**CITY OF SEATTLE  
ANALYSIS AND DECISION OF THE DIRECTOR  
OF THE DEPARTMENT OF PLANNING AND DEVELOPMENT**

**Application Number:** 3008760  
**Applicant Name:** Roger Newell for Washington Land & Investment  
**Address of Proposal:** 1623 Bellevue Avenue

Land Use Application to allow a six story building containing 23 residential units and 1,027 square feet of retail at ground level. Parking for 11 vehicles to be provided below-grade within the structure. Project includes 1,950 cubic yards of grading. Existing structure to be demolished.

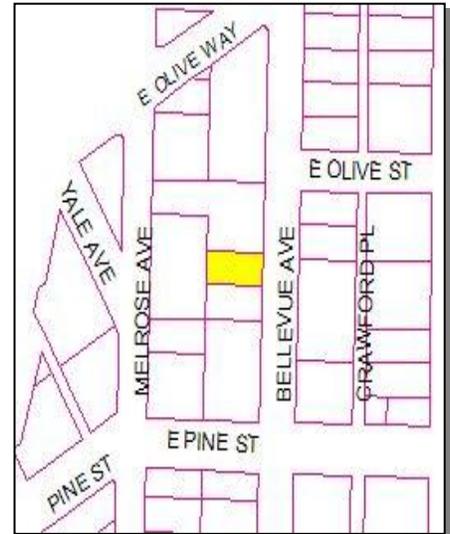
The Board recommends the proposed moment frame expression and stained concrete base, but had concerns about the proposed planters, the durability of the Hardi-panels at exposed corner edges and in proximity to planters, and the lack of details about residential window trim in transition to the panel siding.

The Board discussed the architectural incompatibility and likely maintenance / waterproofing problems of the proposed street facing upper level residential planters and recommended that they not be used. With the removal of the planters, the residential windows should be brought down to, or almost to, the floor level, similar to that proposed on the building's west side. Not using planters will avoid their moisture impacts on the siding panels.

The Board supports the proposed use of Hardi panels as the upper level siding but is concerned that its exposed corners, where it would wrap inward toward the recessed windows and patios, won't withstand moisture impacts and maintain long term visual attractiveness. The Board directs the architect to assure this will not be a problem, and if so, revise this detail compatible with the overall design presented.

The recessed upper level windows proposed should read as assemblies distinct from the "moment frame" element surrounding them. This may require that they extend from floor to ceiling and around corners. The materials that wrap the windows (head, jamb, sill, and corners) must be consistent with the window frames to reinforce the concept of the windows as unified assemblies.

4. Remove the street facing upper level residential planters and bring the residential windows down to, or almost to, the floor level, similar to that proposed on the building's west side. (C-4)

5. Revise the detailing of the exposed Hardi panel corners where it wraps inward toward the recessed windows and patios in order to prevent negative moisture impacts and maintain long term visual attractiveness. The revised detail should be compatible with the overall design presented. (C-4)

6. Redesign the recessed upper level windows to read as assemblies distinct from the "moment frame" element surrounding them. This may require that they extend from floor to ceiling and around corners. The materials that wrap the windows (head, jamb, sill, and corners) must be consistent with the window frames to reinforce the concept of the windows as unified assemblies. (C-4)
